TECHNICAL NOTE: VIEWS OF THE SOUTH DOWNS

Land at New Place Farm, Pulborough

Planning Application Reference: DC/24/1676

9 July 2025

Figure 4: Overlay Development Framework and RM Layout

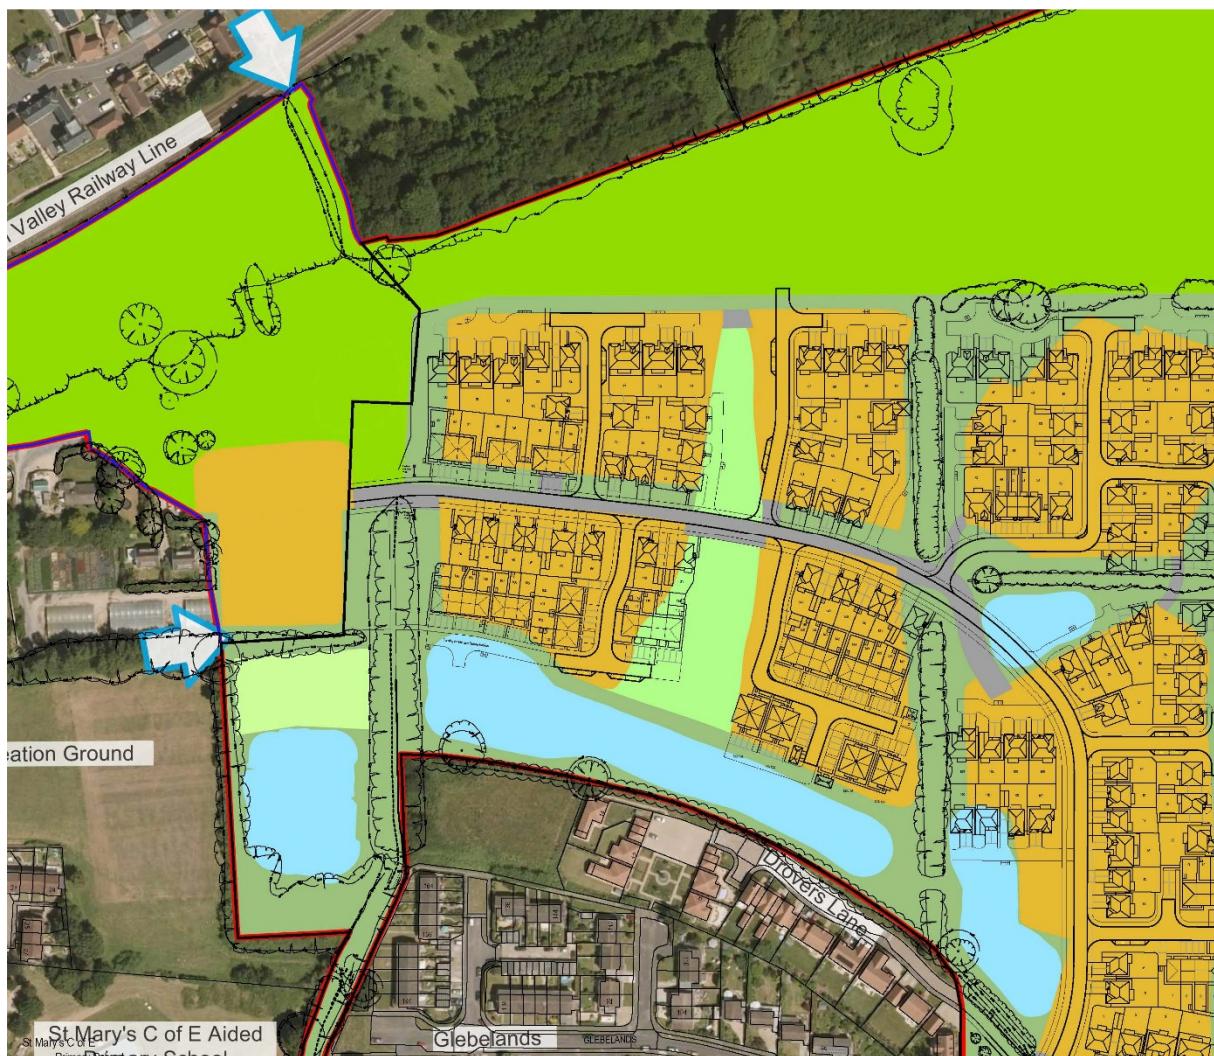
'Significant changes have been made to the framework plan and concern is raised with the effect this has on the existing landscape features; but also, the landscape concept design and key features, such as the landscape framework and the viewing corridor through the site, which is now significantly diluted'.

'central north-south open space was intended to frame some long-distance views towards the South Downs, with an equipped play area, paths and breathing room within the development site – the proposed layout marginalises this open space, fills it with roadways, engineered features, parking bays and a very dense arrangement of houses, gardens parking and likely the associated residential garden boundaries. In contrast to the sweeping vista envisaged in the outline scheme, the new layout squeezes this open space at both ends'.

The overlay demonstrates a significant widening of the northern gateway to the open space, providing greater potential for the enjoyment of elevated views to the South Downs. The alignment of the space is broadly north-south and thus would focus on the most dramatic and

elevated part of the ridgeline (Rackham Hill). The space is continuous from northern to southern parcels and proposed built form is set back further from the built development parameter on the eastern side, allowing a greater appreciation of views in a southerly direction, rather than gentle curve to the south-west proposed at outline stage.

On the western side, the southern parcel extends beyond the limit of the built form parameter, however due to the lower lying nature of this part of the Site, and its position to the west of the main visual focus, it is unlikely that proposed houses in this location will interrupt views of the South Downs ridgeline.
